**PCN# 20130719001
TL4242-Q1 datasheet _ CMS C1306189
Information Only**

PCN Number:	20130719001		PCN Date:	07/24/2013	
Title:	TL4242-Q1 datasheet - CMS C1306189				
Customer Contact:	PCN Manager	Phone:	+1(214) 480-6037		Dept: Quality Services
Change Type:					
<input type="checkbox"/>	Assembly Site	<input type="checkbox"/>	Assembly Process	<input type="checkbox"/>	Assembly Materials
<input type="checkbox"/>	Design	<input checked="" type="checkbox"/>	Electrical Specification	<input type="checkbox"/>	Mechanical Specification
<input type="checkbox"/>	Test Site	<input type="checkbox"/>	Packing/Shipping/Labeling	<input type="checkbox"/>	Test Process
<input type="checkbox"/>	Wafer Bump Site	<input type="checkbox"/>	Wafer Bump Material	<input type="checkbox"/>	Wafer Bump Process
<input type="checkbox"/>	Wafer Fab Site	<input type="checkbox"/>	Wafer Fab Materials	<input type="checkbox"/>	Wafer Fab Process

Figure 6.

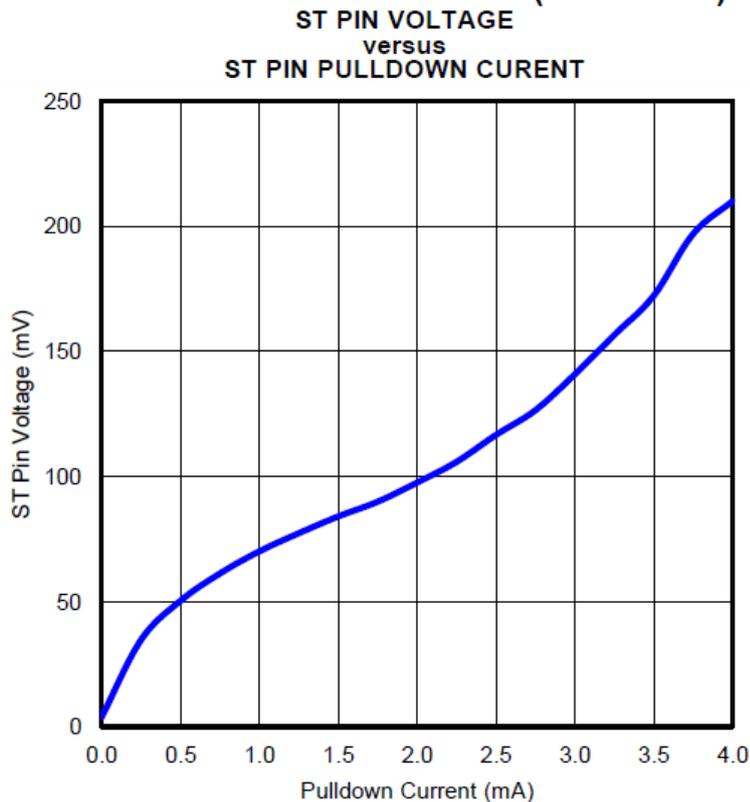
Texas Instruments publication SLVS732 has changed as described below. Figure 6 has been added to page 7.
